Our Ref: 11049\_Response to RFI of 1 Dec 2023\_Final

**RE: Mixed Use Development (Application No 167.1/2023 PAN-333433  
Property: Broomfield Street, Cabramatta**

Thank you for your Request for Information letter (**RFI**) dated 1 December 2023 in respect to the above Development Application (**DA**) lodged on 2 June 2023.

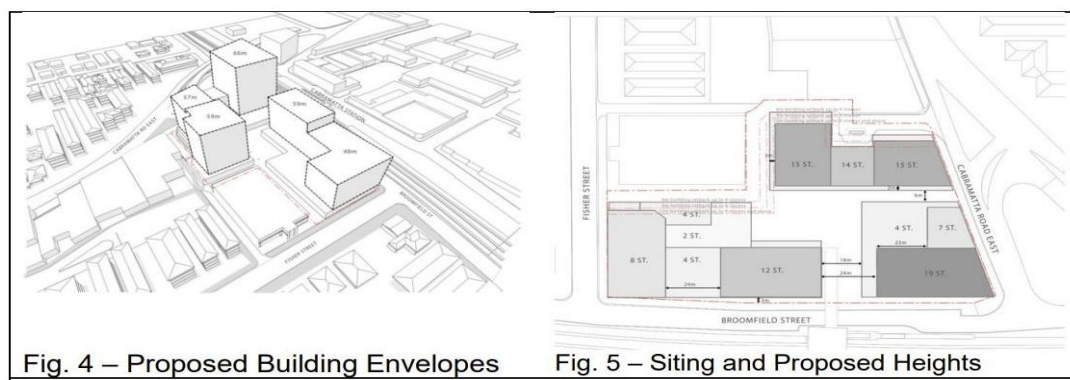
The Council has extracted Figures 4 and 5 of the DCP in its RFI to compare differences in the numbers of storeys and other setback dimensions. These Figures are reproduced below for discussion purposes:

It is noted that the entire discussion in the RFI letter provides an assessment comparing the proposed development only to Figure 5 without reference to the way the plan is intended to work or the clause requirements that reference these figures (both Figure 4 and Figure 5). In this regard, there are two relevant *Development Controls in Section B – Built Form, Siting and Height – Precinct 4A*, being the section from which the diagram above is extracted. The first written Development Control in this section of the DCP that references Figure 4 and is repeated below:

This means that Figure 4 sets maximum heights and footprints for different parts of the site within which the final heights and siting of the building can occur. The proposal is entirely consistent with the heights and is within the building envelopes as established and depicted in Figure 4.

Figure 5 does not in fact set a height or maximum number of storeys, nor does it set dimensions for separation of buildings or setbacks, although some dimensions are shown on that plan. The clause that prescribes the Development Controls that references Figure 5 in this section of the DCP in fact states:
